**N6742B-01**

**S E R V I C E N O T E**

**N6742B 100W DC Power Module**

**Current Measurement accuracy is out of specification when there is voltage being sourced at the output terminals.**

Location of C36 and C37

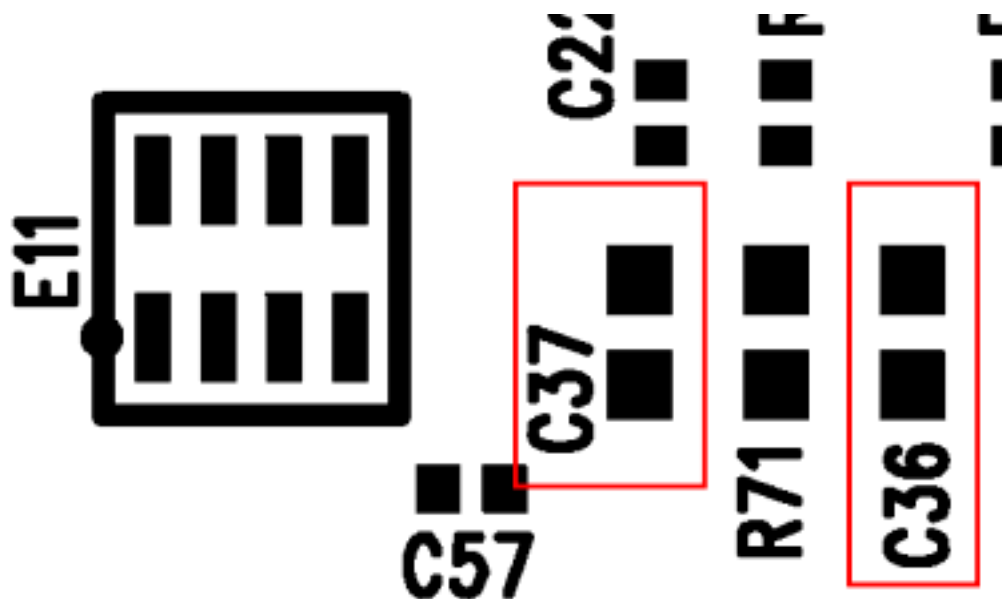
Due to some noise filtering issues, the current measurement accuracy will be out of specification by a fixed offset when there is a voltage being sourced at the output terminals. If the output is shorted, the current measurement accuracy will be within specifications. Please note that the performance verification test will not catch this.

If this measurement is out of specification, replace capacitors C36 and C37 on the DPM assembly (this is the assembly that is vertically mounted in the unit that looks similar to a PC memory module) with part number 0160-7809. After the capacitors are changed, the unit will require re-calibration. After the capacitors are replaced, check the make sure that the unit is in specification by applying 75% of the full voltage range while attached to a load drawing 50 mA to 70 mA. If the current measurement is within the specification, then the unit has been repaired.

Test to see if the module is out of specification by applying 75% of full scale voltage while drawing 50 to 70 mA . Compare the reading to what it should be via the current measurement accuracy spec. If the current measurement is within specification then the capacitors will not need to be changed.
